Validation Report

VALIDATION OF THE CDM-PoA:
PV PROJECT DEVELOPMENT IN CHILE

AND VALIDATION OF THE SPECIFIC CDM-CPA:
PV PROJECT IN LA TIRANA, CHILE

REPORT NO. 600500941

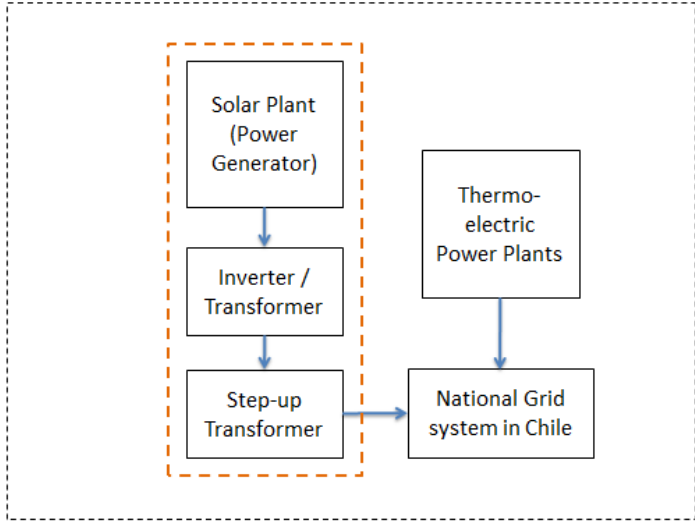
Comments and Results	Conclusion and IRL
Issue	Generalized flow diagram of a typical CPA is not mentioned.	Closed Ok
Requirement	EB 70 annex 06.	
Corrective Action Request	<u>Corrective Action Request No.15</u> The PoA-DD shall be in line with the PoA-DD guidelines.	
Response	<p>Project Boundary</p>  <p>Section B.3 Part II of the PoA-DD updated accordingly.</p>

Corrective Action Requests by validation team		
Assessment	Revised PoA-DD has been validated to have an appropriate generalized flow diagram indicating the project boundary for typical CPA (as per applied methodology). Hence it is acceptable.	
Means of validation		
Adjustment on project design	PoA-DD has been revised to be in line with PoA-DD guidelines, EB 70 annex 06.
